Research Report 1546

MANPRINT Evaluation of the High Mobility Multipurpose Wheeled Vehicle—Heavy Variant (HMMWV—HV)

February 1990

Figure 1. Rear door latching mechanism

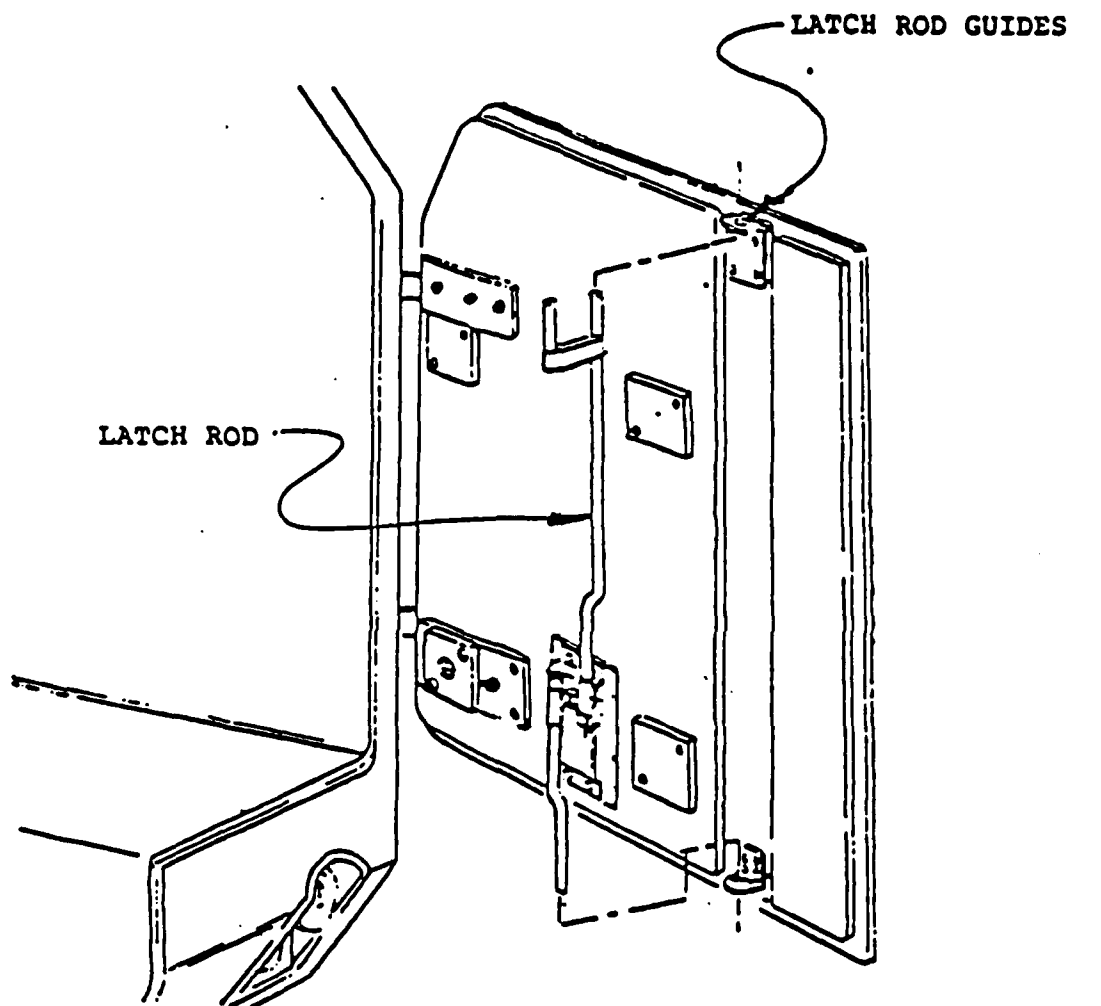
Description of the problem. The rear doors for both the mini- and maxi-ambulances have inadvertently opened during normal operation. The hardware and latching mechanisms involved are shown in Figure 1.

Implications. Unsecured doors pose a safety hazard to personnel inside the enclosure, and may require unscheduled stopping of the ambulance.

Potential solution. To achieve positive locking of the rear doors:

Lengthen latch rod to increase the amount of engagement in the latch seat, and taper the end of the latch rod to facilitate its insertion.

Use a more durable material for the latch rod seat. Also, internally ramp the latch seat to improve latch rod alignment into the seat.

Figure 2. Rear entry steps

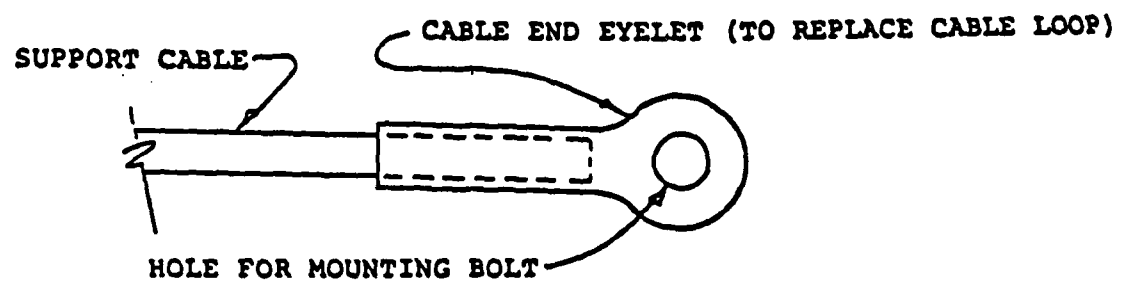
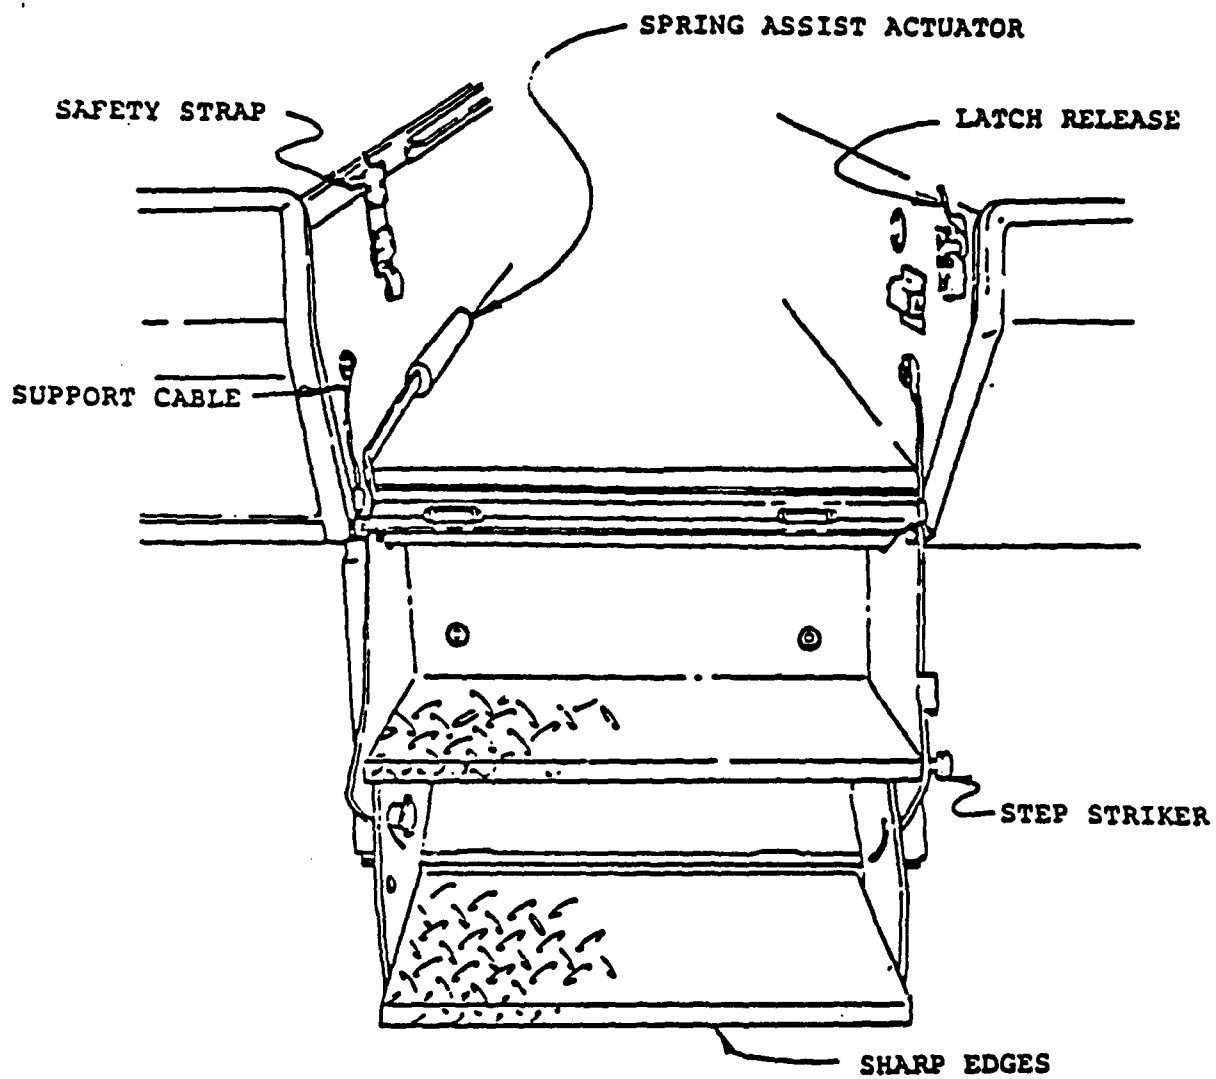
The stair release latch is stiff, prone to sticking, and interferes with the litter support strap in the maxi-ambulance (see Figure 2).

The stair support cables have come off of their attachment fasteners (see Figure 2).

Potential solution. Design the latch with an increased compound lever advantage. Change the direction of the release motion 90 degrees to existing. Move litter support strap to avoid interference.

Stair support cables could be redesigned to incorporate the cable and eyelet (see Figure 2).

Add a warning to the operator's manual and locate a warning at the stair seat to avoid possible injuries.

Consideration should be given to the necessity of a rear stair seat.

Figure 3. Support cable

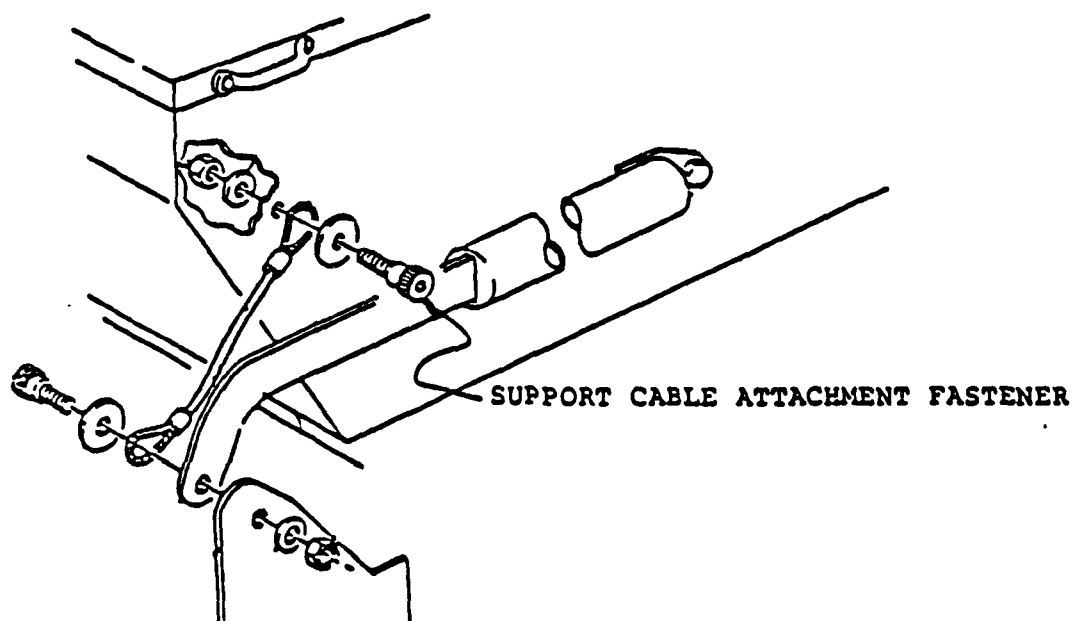
Probable cause. The step latch hardware malfunctions when fouled with dust. The motion to actuate the release lever is lateral to operator's frontal plane and is difficult to grasp and to release. The stair support cable loops wear, increasing their diameter and allowing them to come off their mounting fasteners (see Figure 3).

Figure 4. Handholds for aidmen and ambulatory patients

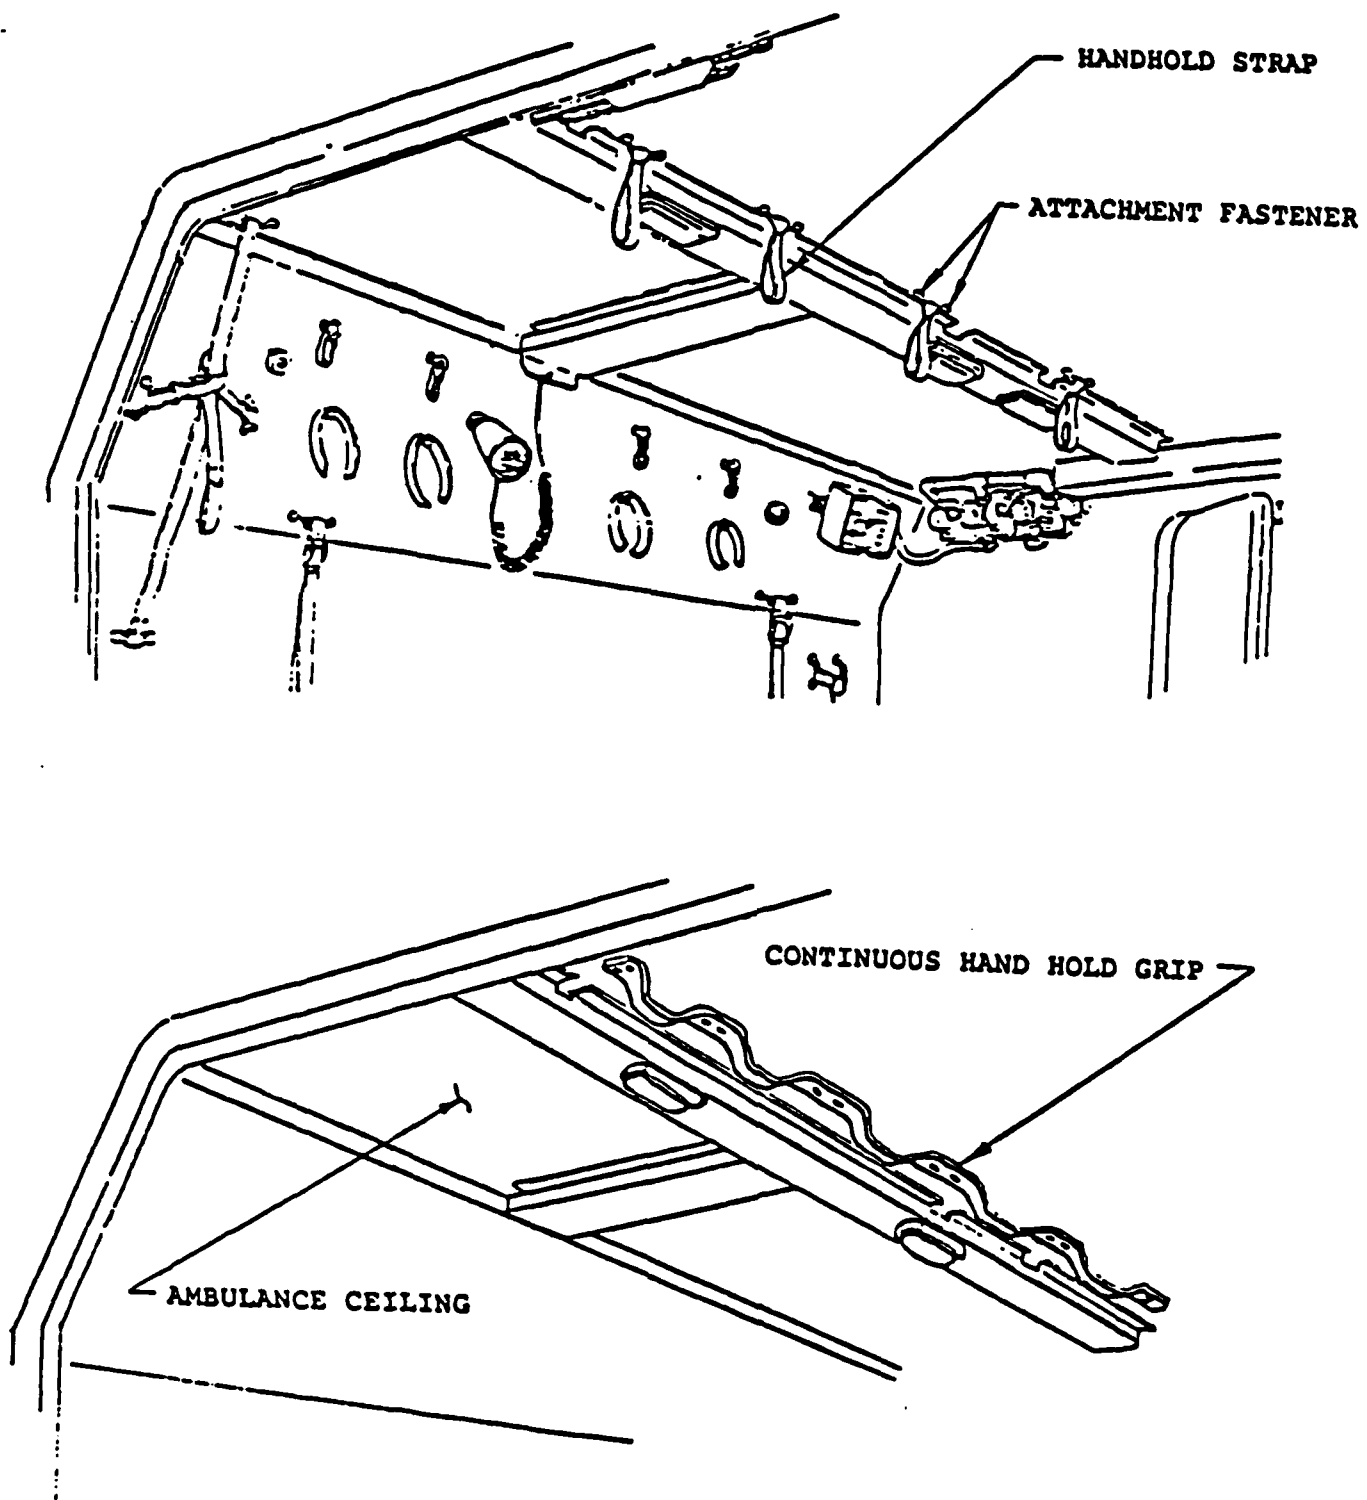
The mini-ambulance has handhold straps for use by seated ambulatory patients. The securing fasteners frequently failed, rendering the strap useless. It is also difficult to slide hands in and out of the hand strap loop (see Figure 4).

Potential solution. Incorporate a self-winding (retractable) seat belt restraint into the split between the seat and back of the ambulatory seat in the mini-ambulance. Incorporate this seat and restraint system into the maxi-ambulance so the upper litter rack could tilt up to provide a storage area for ambulatory patient personal gear.

Add four handhold straps into the maxi-ambulance similar to the hand straps in the mini-ambulance. This will augment the existing four handholds provided by the looped upper litter support straps.

Incorporate a handhold system such as a continuous handhold strap as shown in the lower portion of Figure 4. This will give aidmen a handhold while attending to upper litter patients in the maxi-ambulance.

Upgrade hand strap fasteners in the mini-ambulance.

Figure 9. Sharp edges, rear steps of ambulances

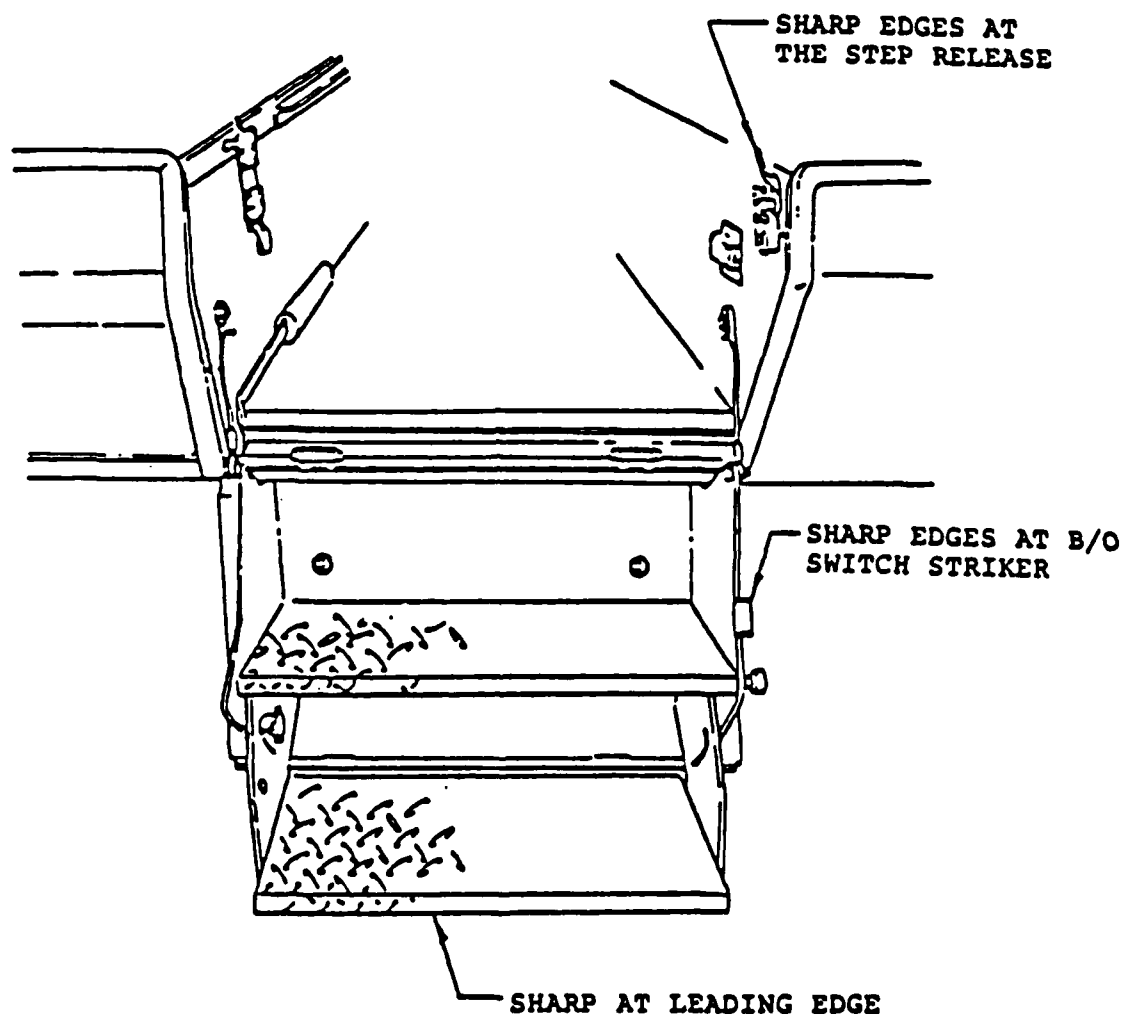
Both mini- and maxi-ambulances (see Figure 9):

Potential solution. Roll all sheet steel edges. Round off or break all appropriate sharp corners.

Figure 10. Sliding seat for aidman

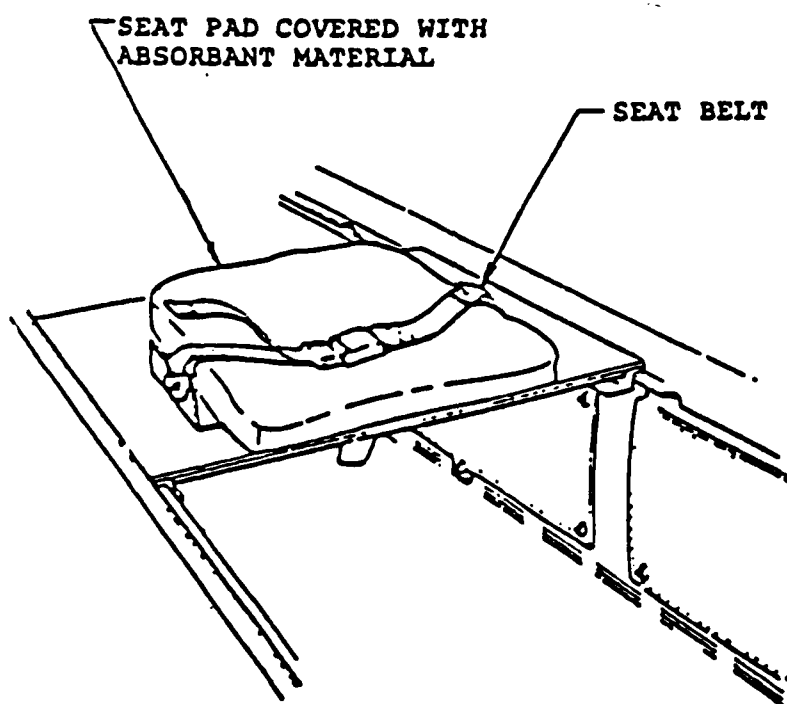
Description of the problem. The attendant seat cannot be locked into a position on its slide track so that the attendant can straddle the seat and work at a patient's head. Attendants are also pitched backward and out of the attendant's seat. Aidmen cannot access the upper litter patient in the maxi-ambulance while secured to the aidman's seat. The seat is covered with an absorbent material (see Figure 10).

Potential solution. Put additional detents into the seat slide track, especially one extra set of detents located directly between the two forward detent sets. Incorporate a folding short lumbar support into the attendant's seat. The back of this folding support, when folded down, could be padded to allow the attendant to also straddle the seat. The folding back could be spring-loaded so the back would fold down when not in use to facilitate stepping over it. Cover the seat with a heavy non-permeable vinyl covering. Incorporate a handhold strap system in the maxi-ambulance to give aidmen a secure handhold.

Figure 11. Door latch handles

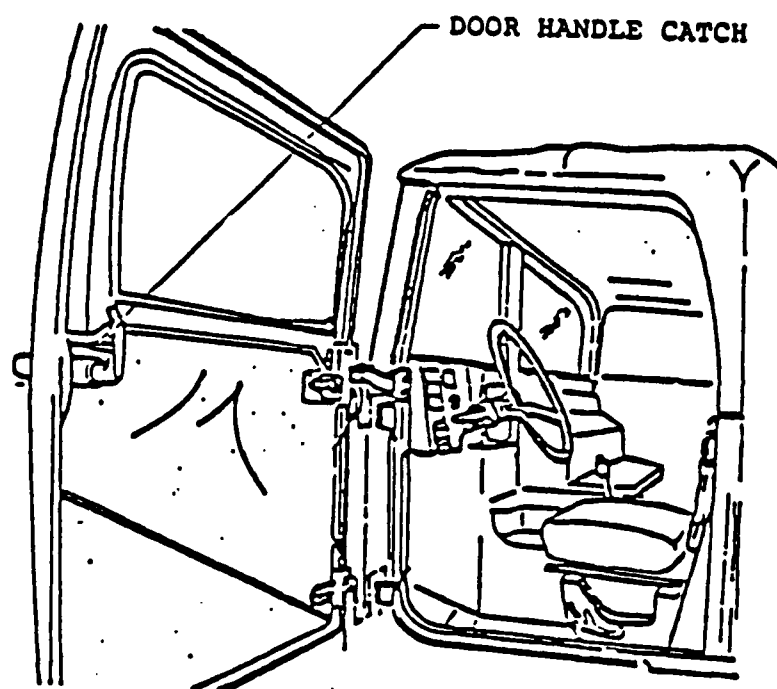
Door latch handles are prone to unlatching (see Figure 11).

Potential solution. Incorporate adjustable cinch straps to adjust back curtain tension. Improve door frame fit and gasket seals. Improve the catch on the interior door handle by increasing the side of the molded catch. Relocate the side mirrors to a position forward to allow the driver to use the mirrors through the windshield. Incorporate a transparent, hard, clear window.

Figure 12. Shelter and tailgate tripping hazards

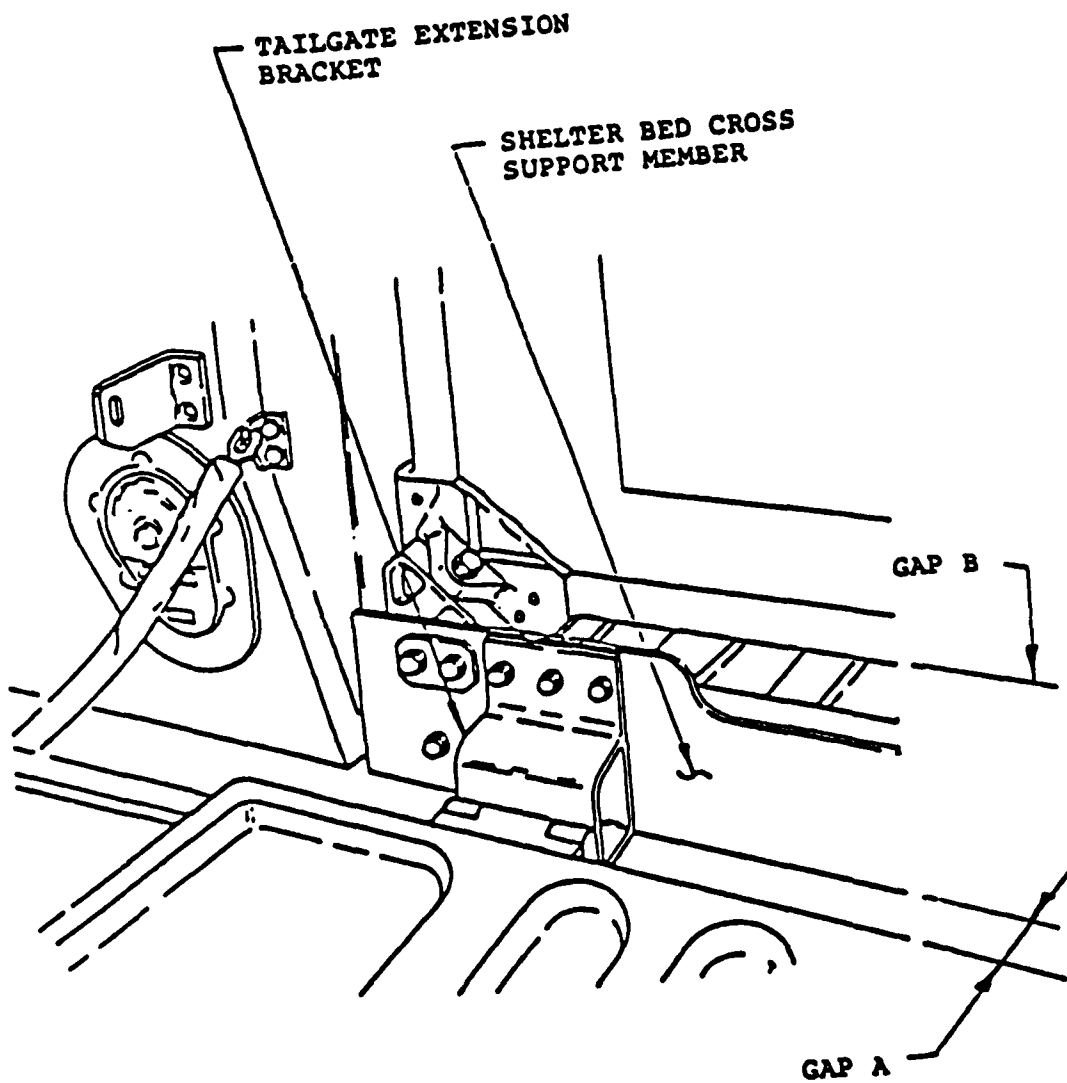
Description of the problem. A tripping hazard exists for HMMWV-HV shelter carrier crewmen while entering or exiting the communications (S-250) shelter. Two hazard locations are shown in Figure 12: one, a gap between the tailgate when lowered and the rear shelter bed cross support member; two, a gap between the bed of the vehicle and the lower edge of the shelter.

Potential solution. Add a horizontal plate attached to the shelter bed cross support member to fill the gap between the cross support member and the tailgate. This plate would be fitted to the cross support member.

Figure 13. Driver's seat adjustment slot

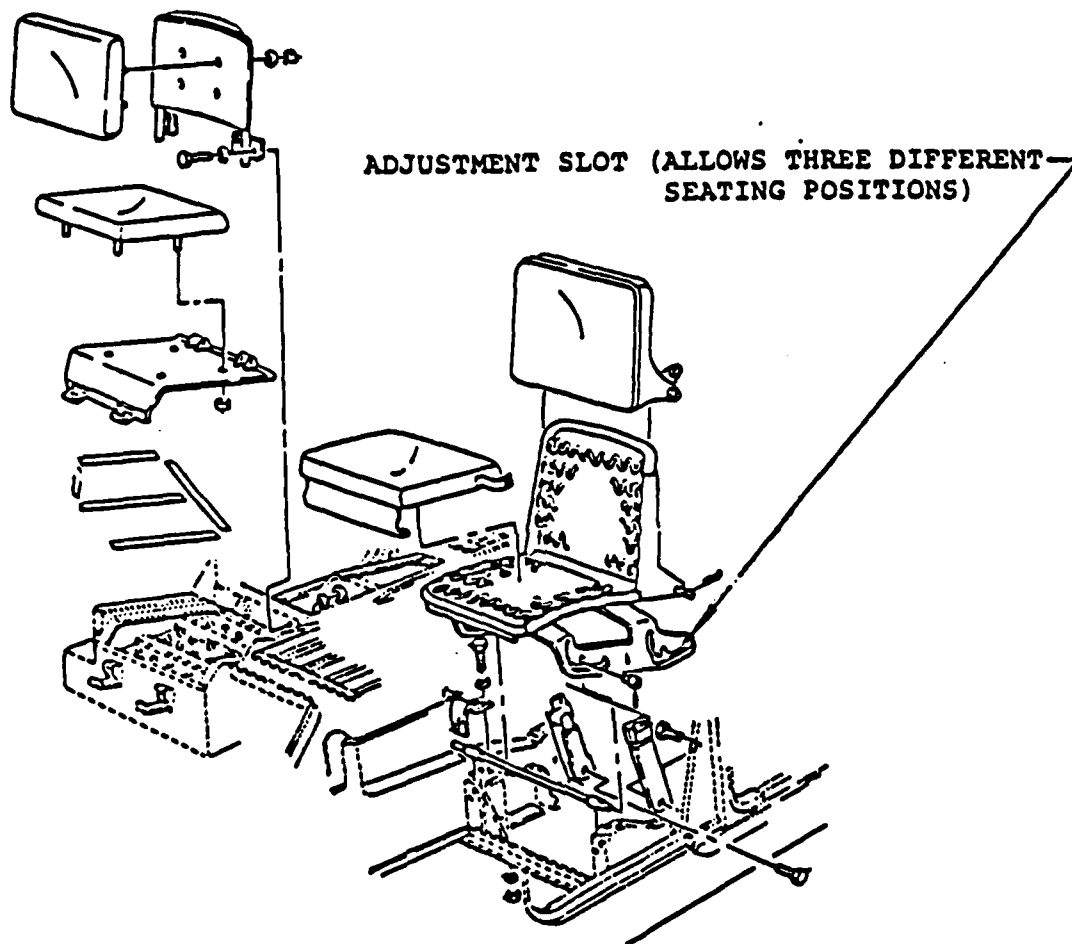
Description of the problem. The width of the HMMWV and non-sloping hood reduce the driver's visibility to see critical frontal areas of the vehicle. The lack of driver's seat adjustment locations contribute to this problem and also leave many drivers with insufficient leg room. The three available seat adjustment positions are shown in Figure 13. Interviews with drivers have provided the following:

Potential solution. Redesign driver's seat to either adjust independently for up and down and front to back, or to increase adjustment positions of existing design.
